PJM Manual 12: Balancing Operations

Revision: ~~324~~

Effective Date: ~~August 21, 2014~~

Exhibit 1: Limit Relationship for Regulation

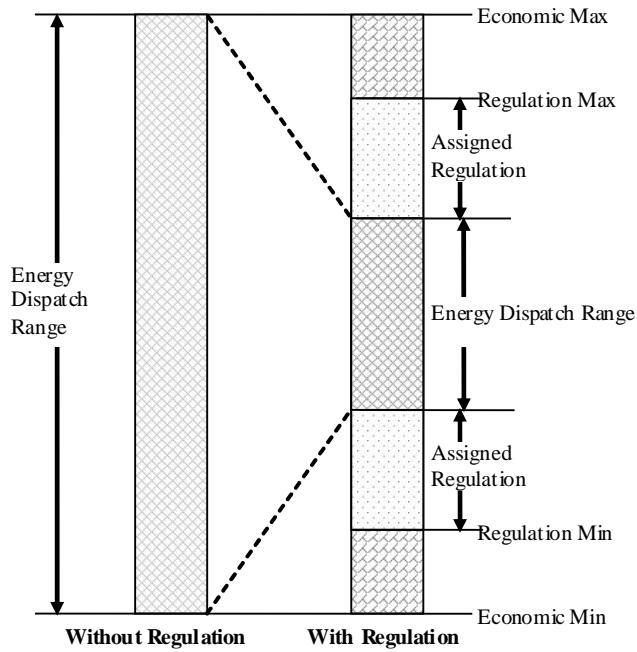
The PJM RTO requires that the Regulation range of a resource is at least twice the amount of Regulation assigned, and that the resource can symmetrically provide the total amount of Regulation assigned (a full raise and lower of assigned regulation from set-point) as illustrated in Exhibit 12 below.

A resource capable of automatic energy dispatch that is also providing Regulation reduces its energy dispatch range by the regulation assigned to the resource. This redefines the energy dispatch range of that resource. (The resource's assigned regulation subtracted from its regulation maximum forms the upper limit of the new dispatch range, while the resource's regulation minimum plus its assigned regulation forms the lower limit of the new dispatch range.) Exhibit 12 illustrates the limit relationship.
